To: **Planning Reps**
From **Highways Development Management Officer**

Your Ref 20211169

Location 5 Brookside Road Istead Rise Gravesend Kent DA13 9JJ

Google Street View October 2016 showing cars parked at number 11. Note the restricted pedestrian access to the property and the overhanging bonnet of the car parked in front of the garage.

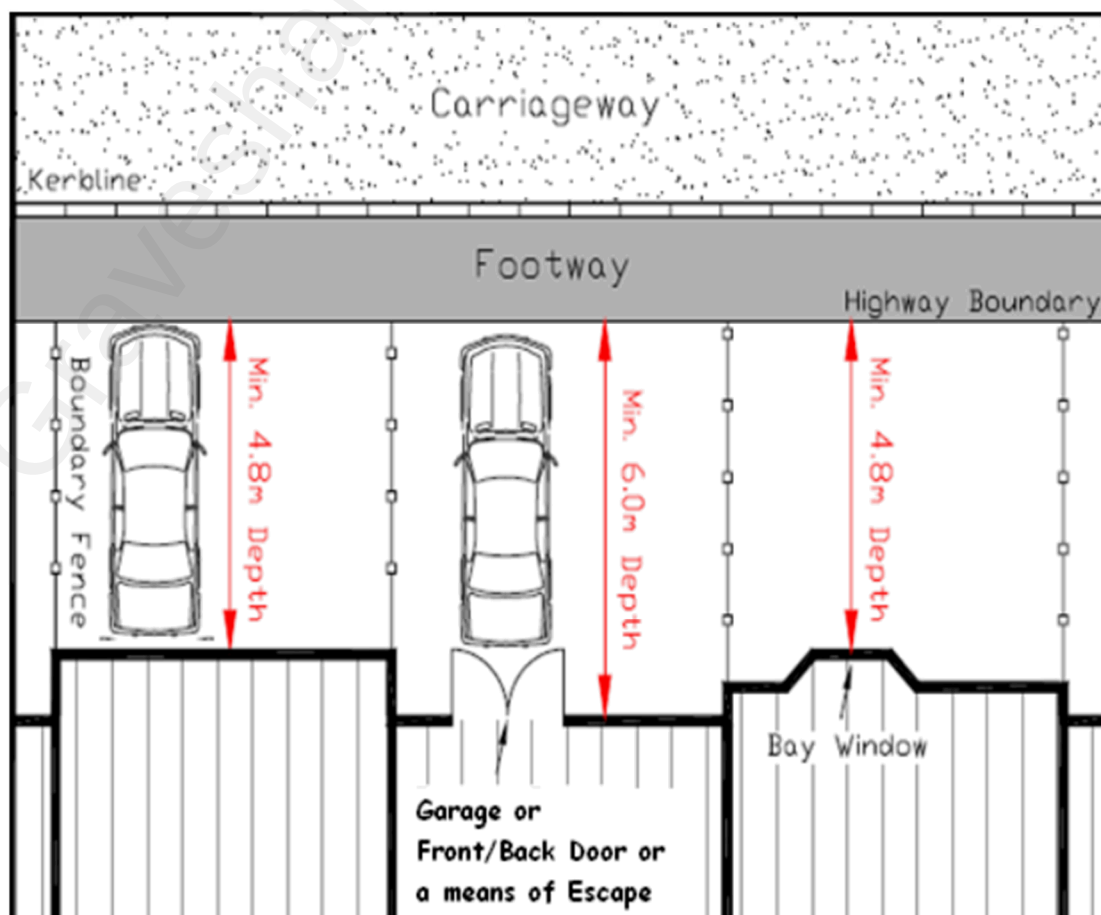
In terms of the car parking requirement, the space in front of the garage is accepted as a parking space as it has been accepted as such in the past. However, any new space would have to conform to current standards. In Kent a standard parking space is 2.5 metres wide by 5 metres long, but these change under certain circumstances. When a parking space is adjacent to a raised boundary the width increases to 2.7 metres to ensure there is adequate space to open the door, which would usually borrow space from the adjacent area. The length increases to 6 metres in front of a door or gate that provides access to a property to ensure there is adequate pedestrian access/egress, particularly in an emergency. The highway authority's general requirements also include parking spaces should be perpendicular to the highway, as this improves the visibility for emerging drivers, which requires a widened carriage crossover. Any driveway should be constructed from a bound permeable material as gravel etc. can be dragged onto the highway where it becomes a hazard.

From the information submitted, I cannot ascertain if it is possible to provide suitable car parking. As such until some information is submitted, I can only suggest the application is refused.
